Re: Banff Trail Area Improvements - Technical Comments

16th Avenue N Lane Widening (& WB Off-ramp to Crowchild Trail)

Image 4: Ontario Traffic Manual example of setback of cycling accommodation from intersection.

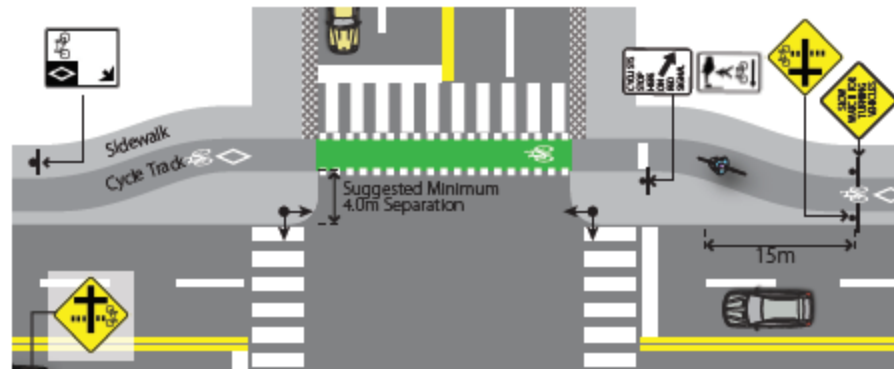
- Unspecified (~22A Street) - Again, detail is lacking in terms of a cycling framework. We also identify that the shift in the crosswalk (assumed multi-use crossing) location closer to 16th Avenue than the adjoining pathway is the opposite of what we understand to be intersection guidance for bicycle facilities, whereby a setback is used to improve safety by making cyclists more visible to turning drivers, i.e. NACTO’s guide “Don’t Give Up the Intersection” suggests a 14-20ft (4-6m) setback, while Ontario Traffic Manual Book 18 shows 4m (see Image 4).
